Source: Leece-Neville Heavy Duty Systems Division -
Arcade, NY USA
Date: February 20, 2007
Subject: Alternator Clearance Issue on Mercedes 926
Engines
Bulletin No: TSB-1052
Models: 4900 Series Alternators

Technical Service Bulletin

Bracket depicting area of interference

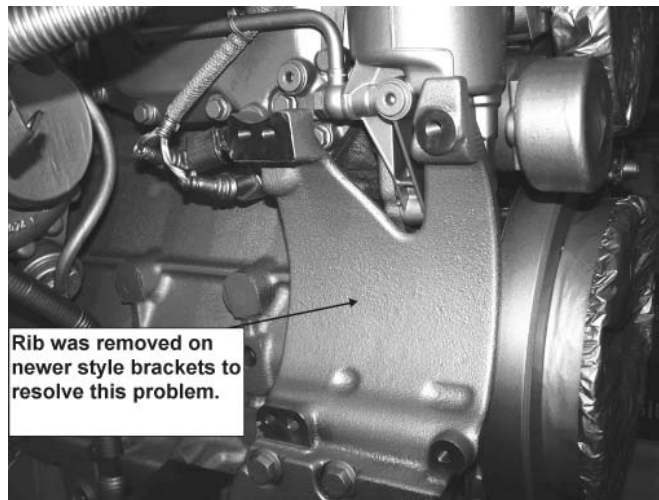
On some Mercedes 926 (190-260 HP) engines, the engine bracket which the alternator mounts onto will not accommodate some Leece Neville 4900 series alternators. The detail below illustrates the abutment that is present on a limited number of engines.

Limited production bracket with abutment

Current production mounting bracket

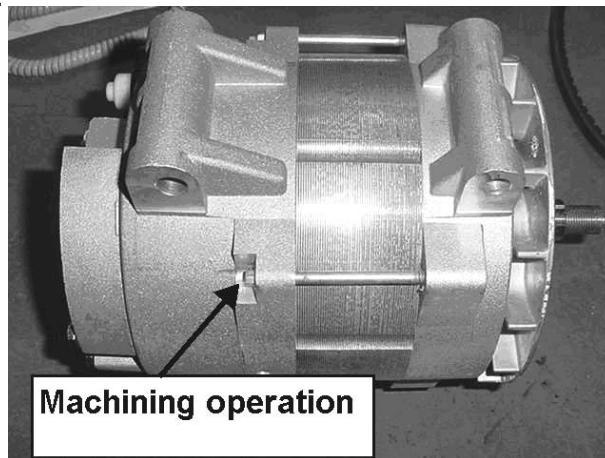
If your engine has this bracket, Leece Neville modified the housing through an additional machining process to resolve this problem for an interim time period to resolve this issue prior to the engine manufacture modifying the bracket. Below are pictures showing the modification made by Leece Neville.

The alternator applicable to this application is Leece Neville part A0014939PGH 14 volt 185 amp alternator.

Note: This clearance issue only exists on Leece Neville 4900 series (185 amps to 320 amps) alternators. All other Leece Neville alternators do not have this problem and will fit on this bracket.
